ROCKY MOUNTAIN ENERGY COMPANY

June 19, 1980

Re: License No. SUA-1338, Reno Creek Project;
Amendment Request of April 23, 1980

CARBONATE PROCESS, ADSORPTION & ELUTION

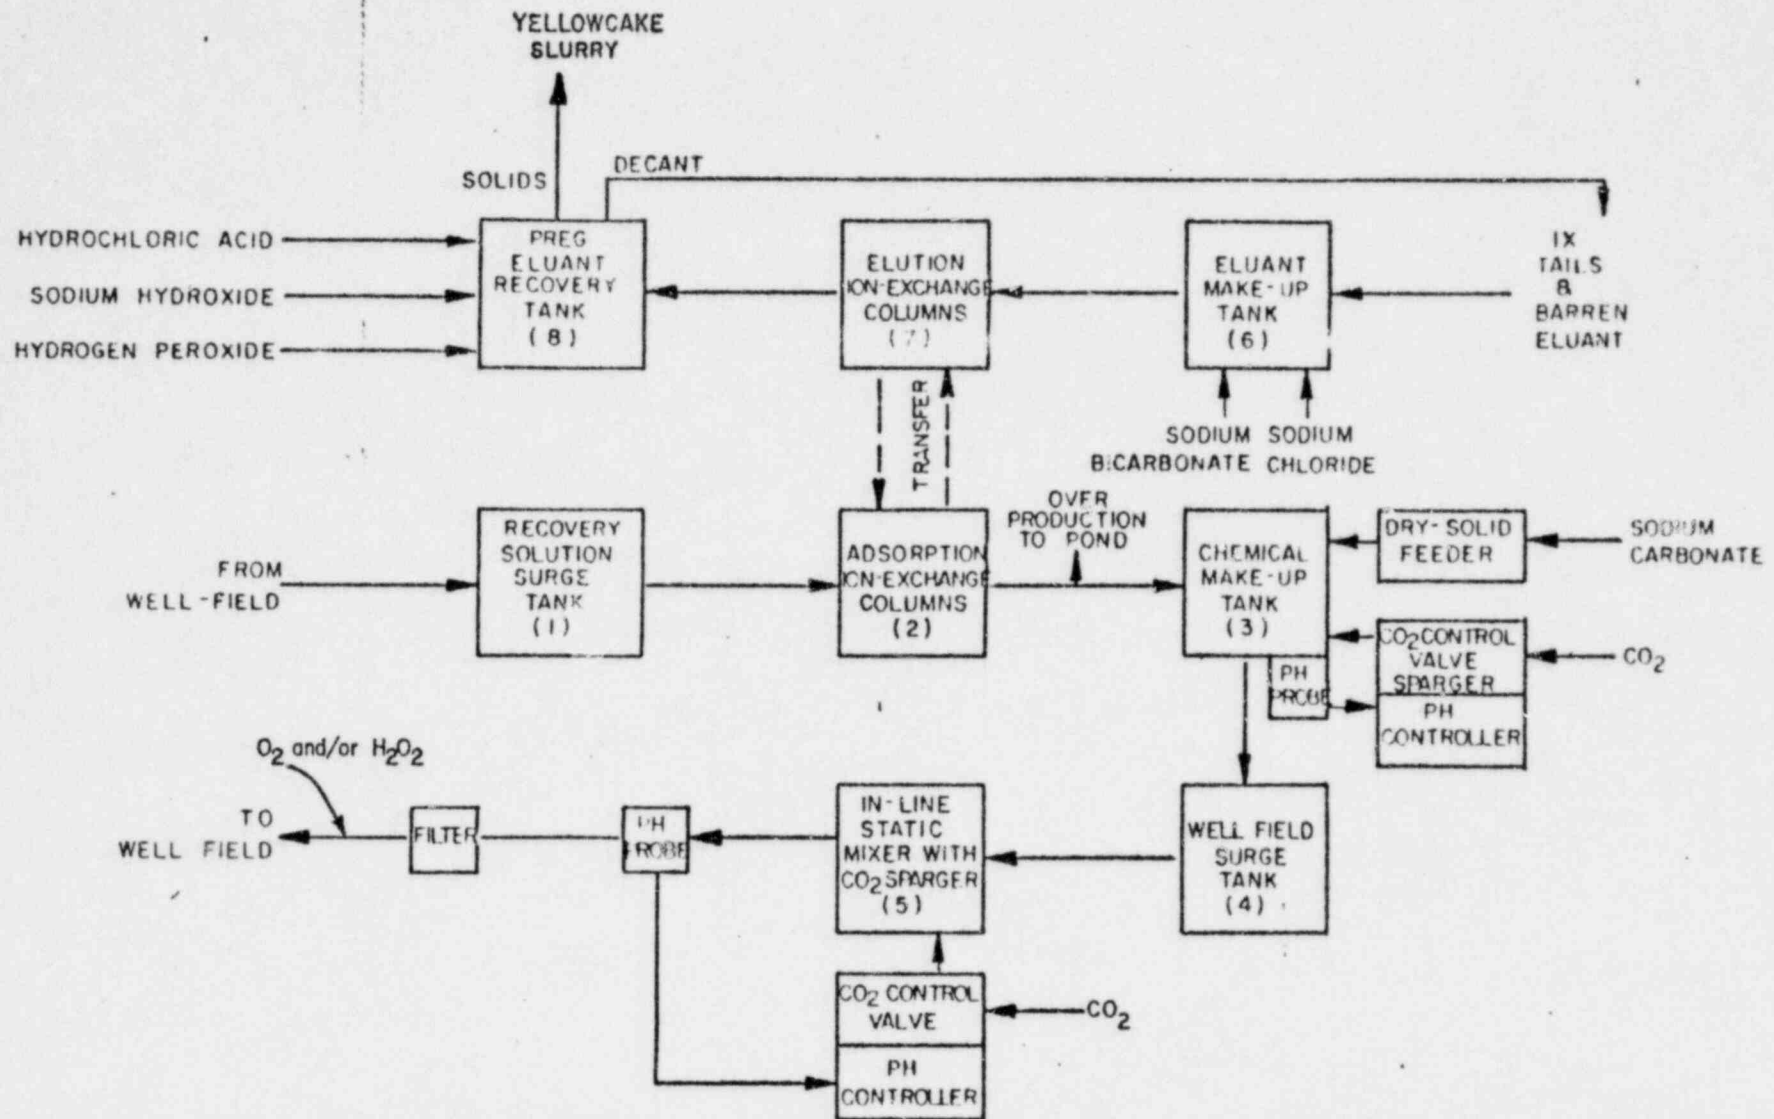
Figure RC-P-05-001 has been redrawn to depict the addition of oxidant to the leach system and is shown as Attachment A. As at the Nine Mile Lake facility, oxidant in the form of gaseous oxygen or liquid hydrogen peroxide is added to the leach solution just prior to wellfield injection. Quantities will vary with geologic and wellfield conditions as required to maintain an economic level of uranium in recovery solutions.
